Citizens' Oversight Projects (COPs)

Mar 12, 2019

To: San Onofre "Move the waste" Expert Team
Fm: Ray Lutz, Citizens Oversight
Re: Communication to and Request for
Information from San Onofre Settlement Expert
Team

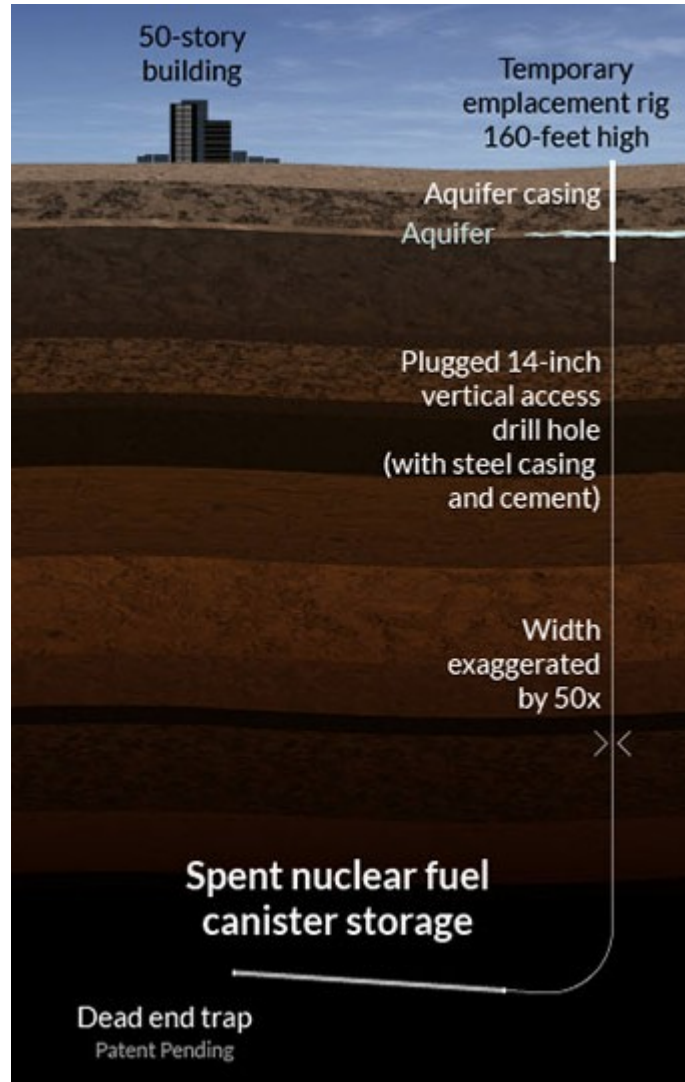
Essentially, this design leverages the recent advances in drilling technology gained through hydraulic fracturing in the petroleum industry, so as to create a deep borehole that goes straight down at first and then once it is far underground, turns and runs roughly horizontally and slightly up. Canisters are emplaced in the horizontal leg. The upward tilt keeps any fume that may be emitted, should they tend to rise. This horizontal leg is the big difference with previous deep borehole proposals that had only a vertical hole.

The waste must be placed in smaller canisters which hold a single fuel assembly. These canisters are inserted into the hole and slowly pushed to the bottom and up the sloping horizontal storage leg.

Please include the deep borehole option in the options being considered. Please include a statement of whether this has already been considered in your response.
